Proposed Revisions to a Standard Plans Index

Index Number: 700-010

Index Title: Single Column Ground Signs

Change minimum Driven Post Hole Diameter to 12"

DRIVEN POST DETAIL

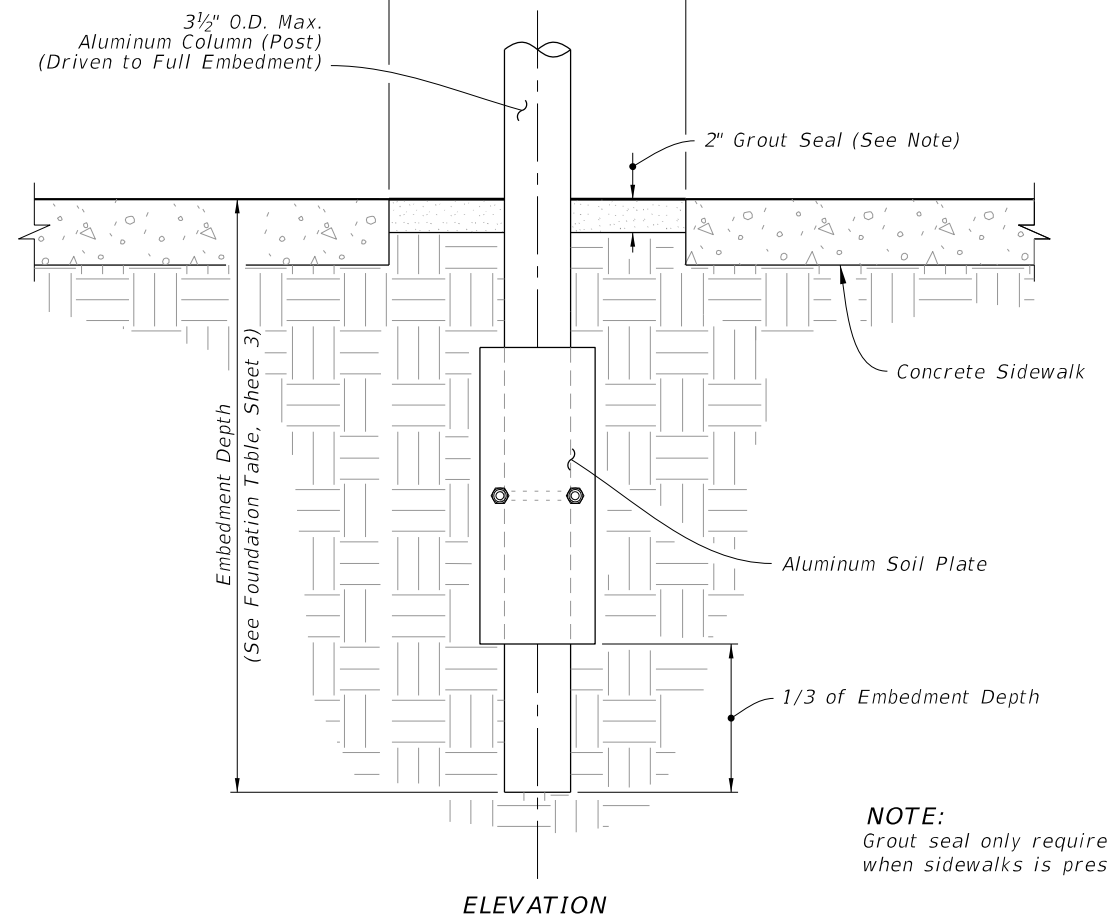
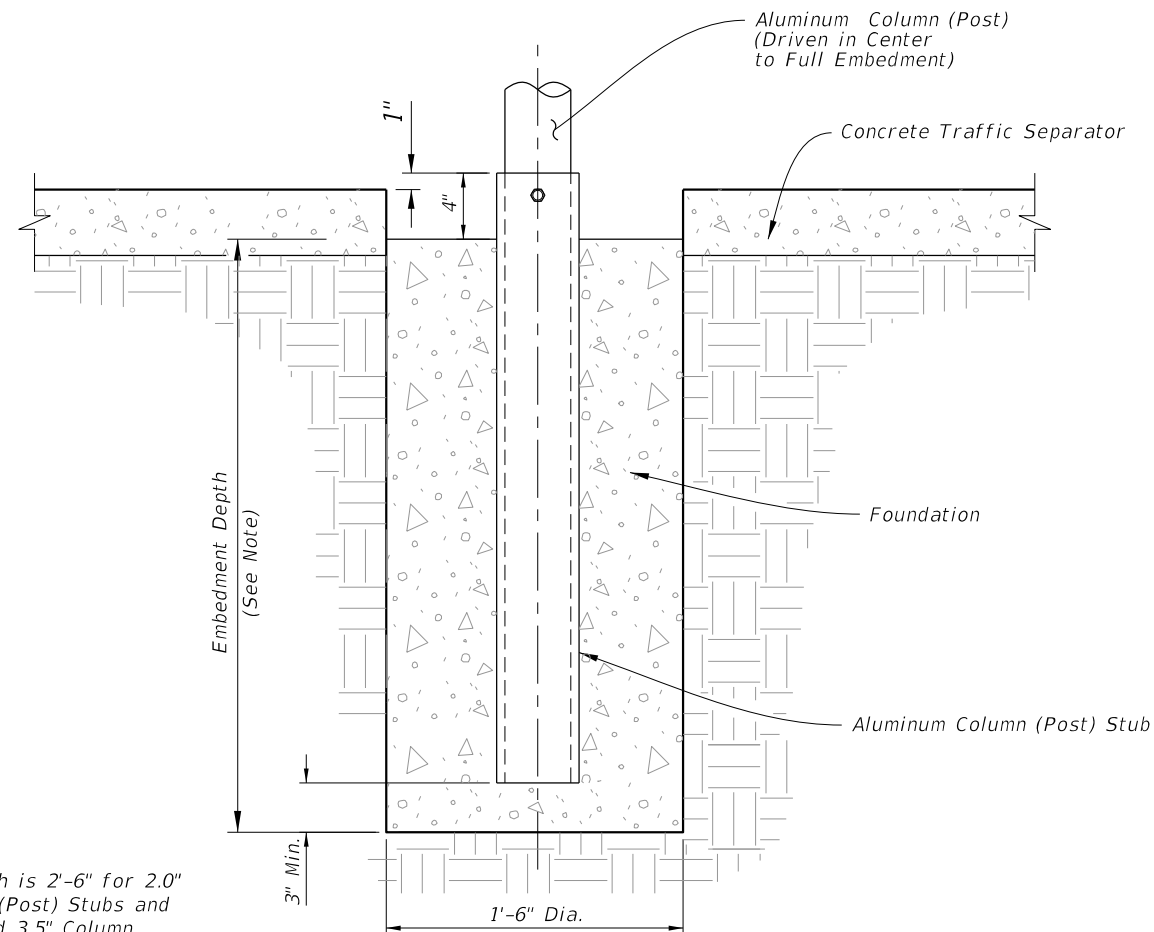
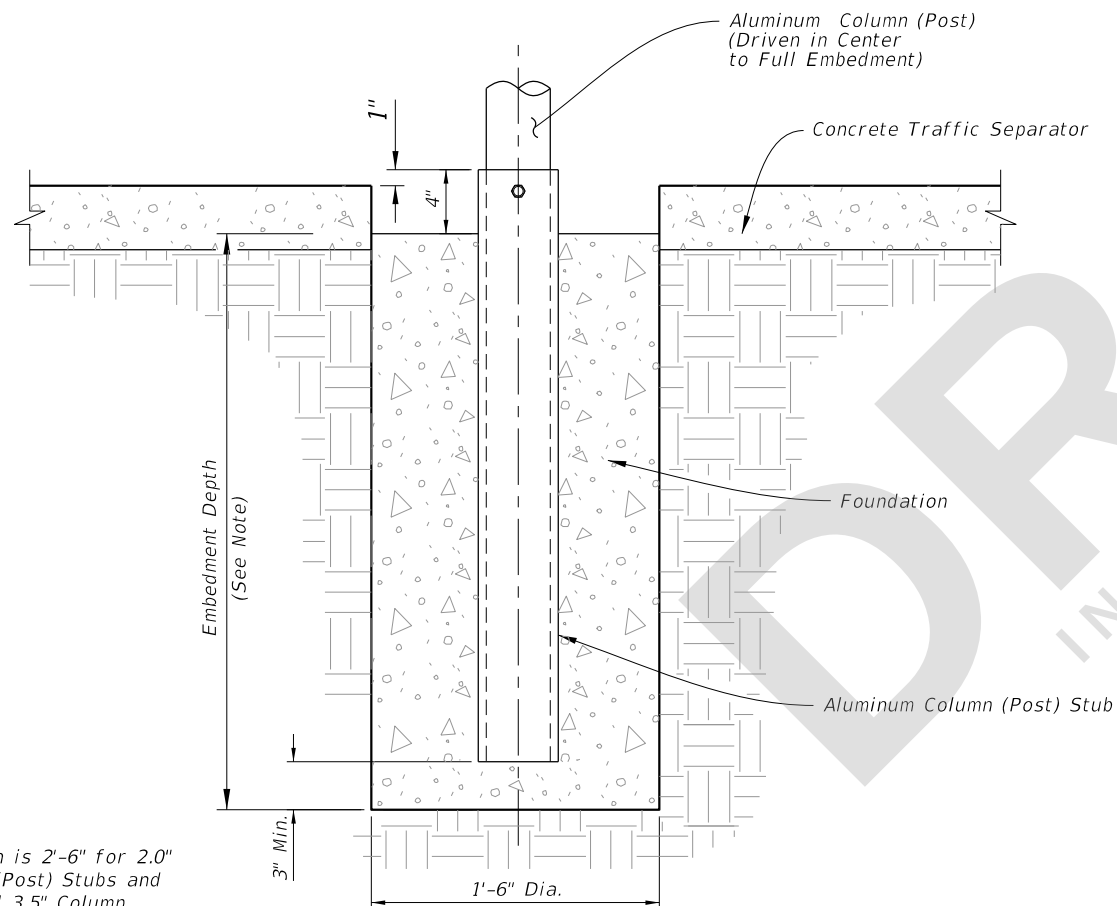
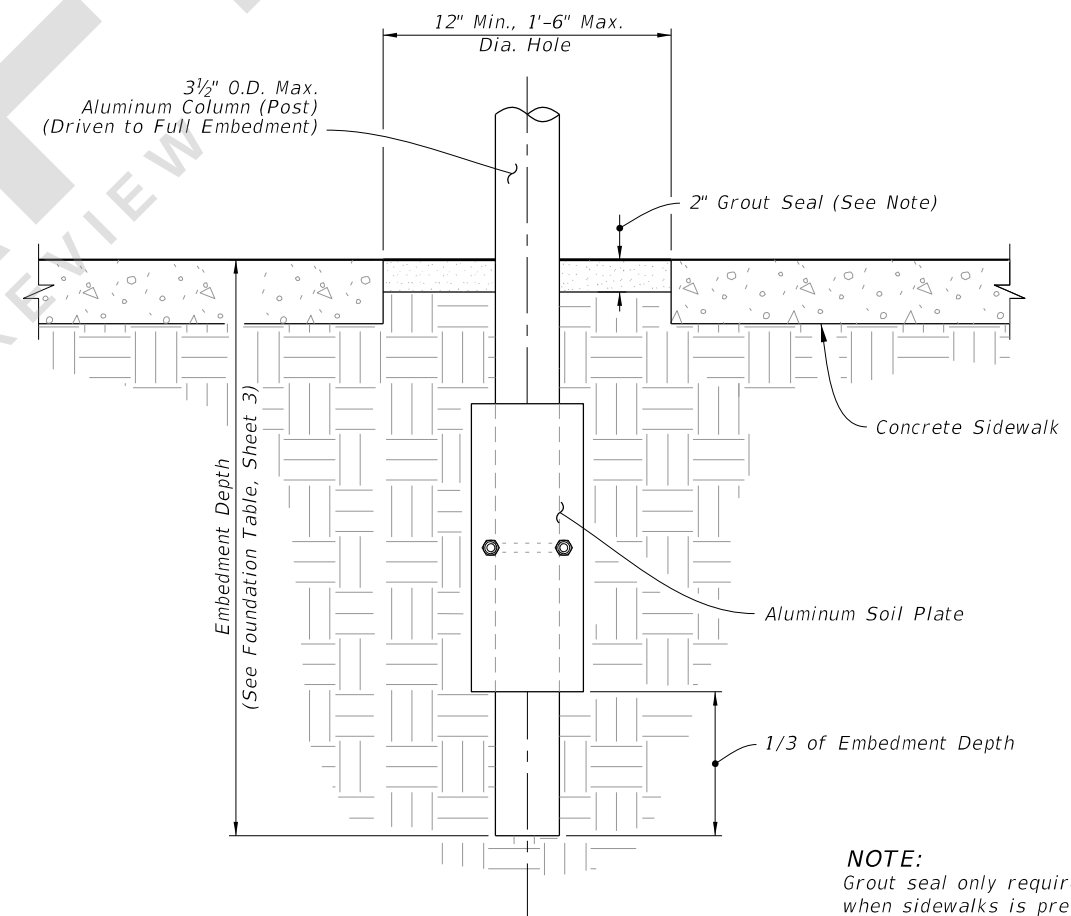
This change was requested by D7 Operations and coordinated with CO Maintenance and Construction. The 8" hole does not allow adequate space to remove old columns for replacement.

8" Min., 1'-6" Max.
Dia. Hole

12" Min
